Regarding: 07V-039

Techn **BULLETIN**

2002 ~ 2007 XV17PC MODELS

FACTORY MODIFICATION CAMPAIGN – Pick-Up Coil

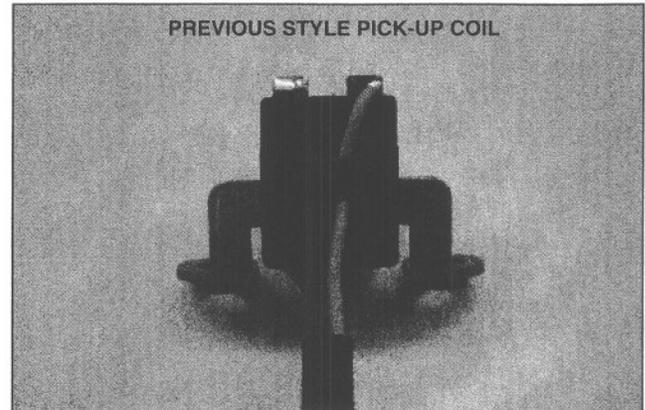
The pick-up coil mounting stay (bracket) is not sturdy enough to prevent vibration caused by magnetic force as the pick-up rotor passes the pick-up coil if the clearance between them is insufficient. The vibration can eventually weaken the lead wires and cause them to break.

To correct this defect, Yamaha is initiating a Factory Modification Campaign. Affected motorcycles must have the pick-up coil replaced with a new one that has a strengthened stay and also has a molded protector over the lead wires to protect them from vibration.
